Project 28 Lockwood Avenue, Belrose

Report Access 2019 Report

Reference C21844-Access-Report-r1

Date 27 September 2022

Annexure B – Lift Numbering

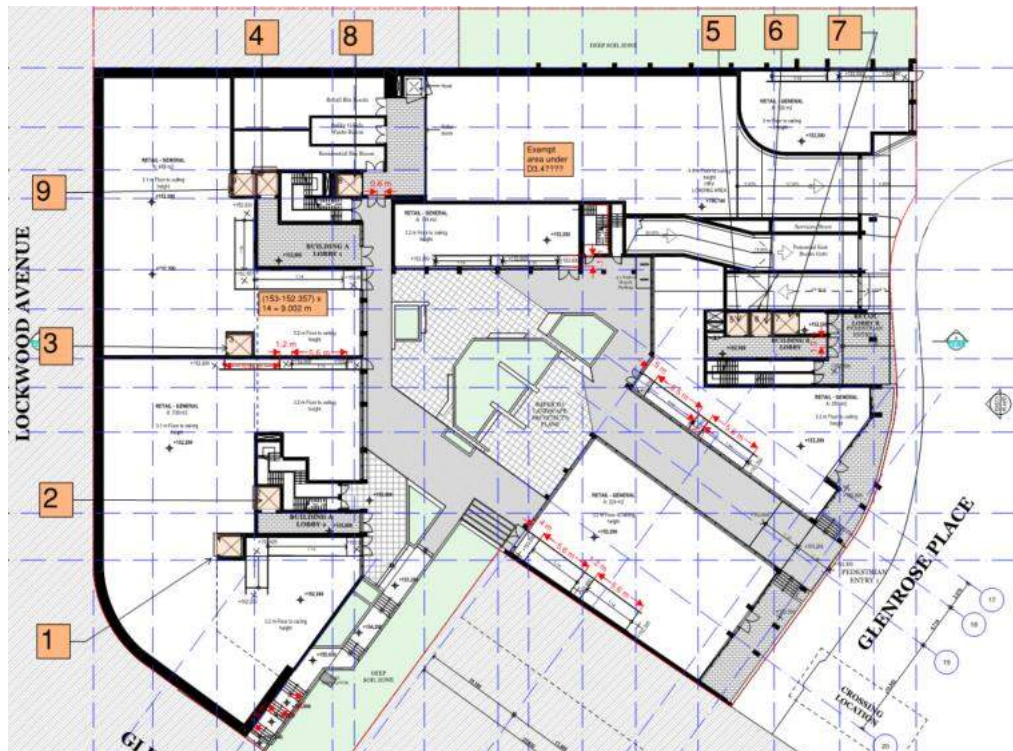
For this Report the lifts have been numbered as below:

Lift	From	To	FFL from	FFL to	Vert. (m)	Requirement E3.6	Plans Scale to
1	B04	GF	144.8	158.7	13.9	1600x1400	2300x2100

2	B04	L01	144.8	161.9	17.1	1600x1400	2300x2300
3	B04	GF	144.8	158.7	13.9	1600x1400	2300x2100
4	B04	L01	144.8	161.9	17.1	1600x1400	2300x2100
5	B04	B02	144.8	152.2	7.4	1400x1100	2200x2100
6	B04	L01	144.8	161.9	17.1	1600x1400	2300x2100
7	B04	L01	144.8	161.9	17.1	1600x1400	2300x2100
8	B03	B02	147.9	153.0	5.1	1400x1100	2300x2100
9	B02	GF	153.0	158.7	5.7	1400x1100	2300x2100
Hoist	Waste	LD	153.0	150.7	2.3	1400x1100	1700x1600
